City of Keene Planning Board

AGENDA

Monday, November 28, 2022

SPR-964, Mod. #7 – Site Plan Review– Hampton Inn Landscaping – 120 Key Road

LANDSCAPE AS-BUILT PLAN
HOTEL SITE
JAZZLYN HOSPITALITY II LLC
120 KEY ROAD
KEENE, NH

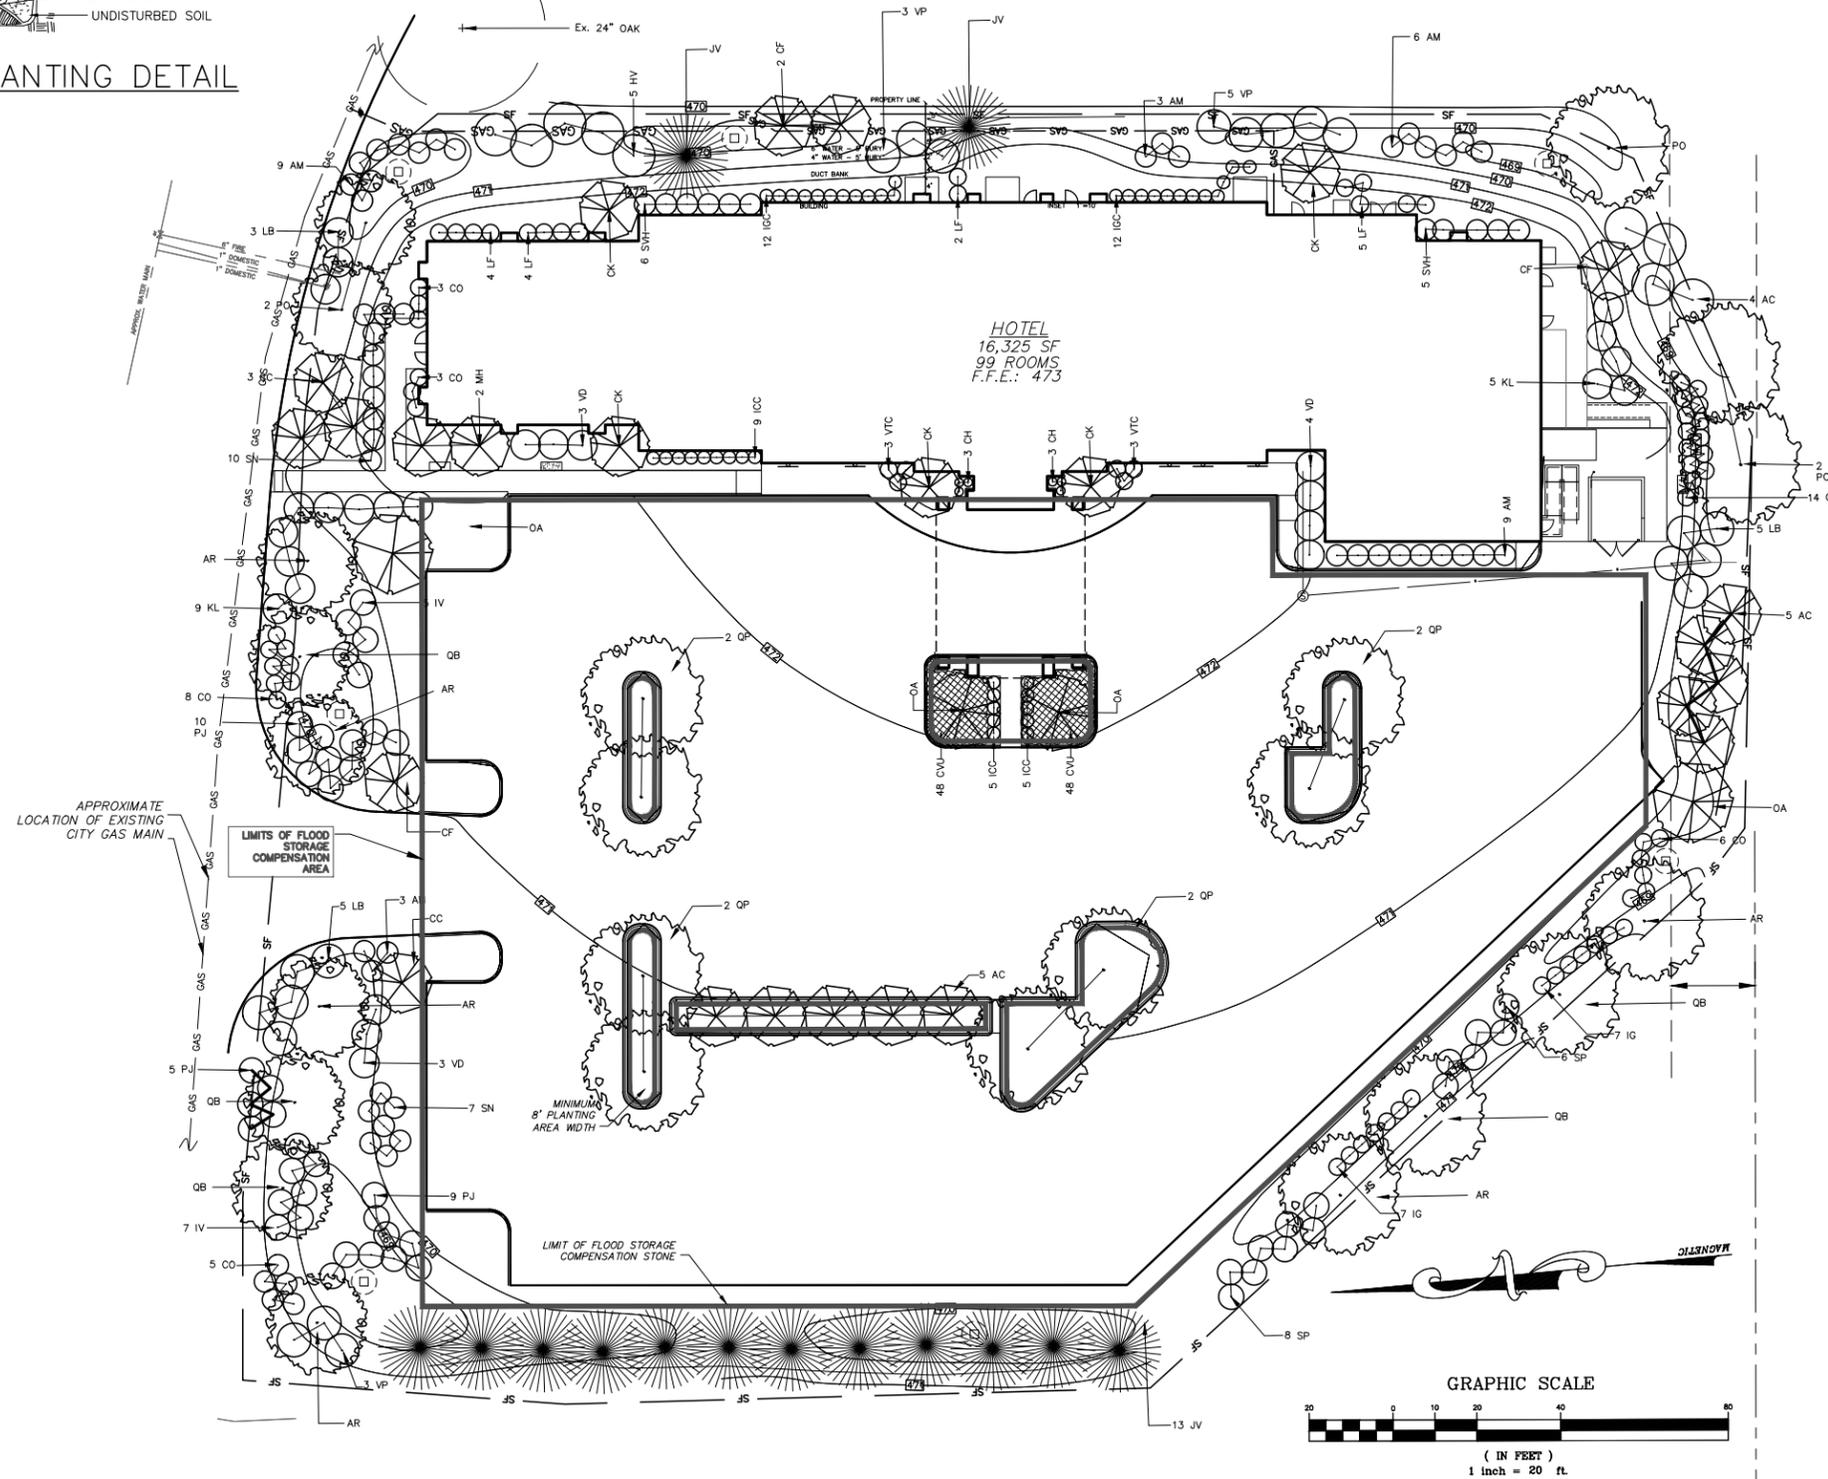
- 20.5 **Landscaping:** According to the applicant, the location of the installed landscaping deviated from the approved landscaping plan in order to accommodate underground utilities and stormwater structures such as detention basins. The original approved landscaping plan did not take into account these site features. Field changes were made to ensure that the landscaping did not conflict with the other site features. The table below includes a comparison of the number and general type of plantings that were approved to the plantings that are installed.

During a conversation with the applicant, it was revealed that a surveyor and not a landscape professional was utilized to create the as-built Landscape Plan. During the installation of the plantings, the landscapers removed the identification tags on the plants. Due to the removal of the identifying tags, the planting species could not be identified by the staff conducting the work. In addition, because the plants were provided from various sources, the applicant does not have a list of the species that were planted. This lead the applicant to use a general description of the plantings and not the specific species in the planting schedule.

Section 20.5.1.A of the LDC states *“No plant material shall be installed on a site that is listed by the NH Department of Agriculture, Markets and Food as an invasive species.”* It is not possible to determine whether this standard has been met. Should the Board wish to approve this application, staff has included a recommended motion to address this. Without information about the species that were planted, a waiver request from this standard would be required.

Section 20.5.1.B of the LDC states *“Plant materials shall be hardy to regional climate conditions per the U.S. Department of Agriculture’s Plant Hardiness Zone Map.”* It is not possible to determine whether this standard has been met. Should the Board wish to approve this application, staff has included a recommended motion to address this. Without information about the hardiness zone for each of the plant species that were planted, a waiver request from this standard would be required.

Section 20.5.4.C of the Land Development Code states *“All landscaping approved as part of a site plan shall be considered as elements of the site in the same manner as parking, building materials and other site details.”* Staff believes that information about the species of plantings is an important part of the record of this project and without these details, future enforcement actions related to landscaping may be challenging.

- 20.6 **Screening:** The project at the time of approval was required to provide a minimum of 1 shade tree and 10 shrubs per 35 linear feet of frontage along the public right-of-way. The project is required to install a minimum of 3 trees and 30 shrubs for perimeter landscaping and 11 trees for interior landscaping. The as-built landscaping plan shows 11 trees along the right-of-way, at least 60 shrubs

and at least 70 interior trees. The spacing of these plantings is less than 35 feet and provides adequate screening for the parking lot. All utility hookups visible from the public right-of-way, including a large transformer located on the northeast corner of the property, have been properly screened by landscaping. It appears that this standard has been met.

- A. Prior to final approval and signature by the Planning Board Chair, the following conditions precedent shall be met:
 1. Submittal of a revised Landscaping Plan with the following information added:
 - i. A planting schedule that reflects the invoices submitted to the Community Development Department and includes the scientific names of all plantings on the schedule.
 - ii. A data table that indicates the required and installed quantity of landscaping to ensure compliance with zoning and site development regulations.
 2. Submittal of five full sized paper copies and one digital copy of the final plan.

Figure 1. Aerial image of the property located at 0 Drummer Rd (parcel shaded in yellow).

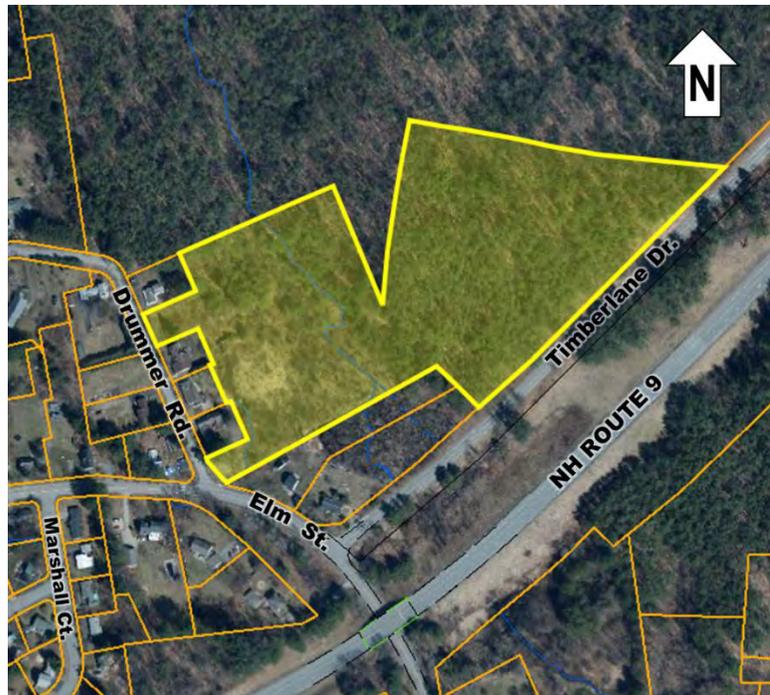
There are forested wetlands located on the west side of the property in the area that is proposed to be conserved as open space. In addition, there are steep slopes in the area of the site that is proposed to be developed, which are shown on the Existing Conditions Plan. However, due to

the fact that no slopes greater than 25% grade (prohibitive slopes) will be impacted by development, and less than 20,000 sf of slopes that are between 15% and 25% grade (precautionary slopes) would be impacted by development on any individual lot, a Hillside Protection Conditional Use Permit is not required.
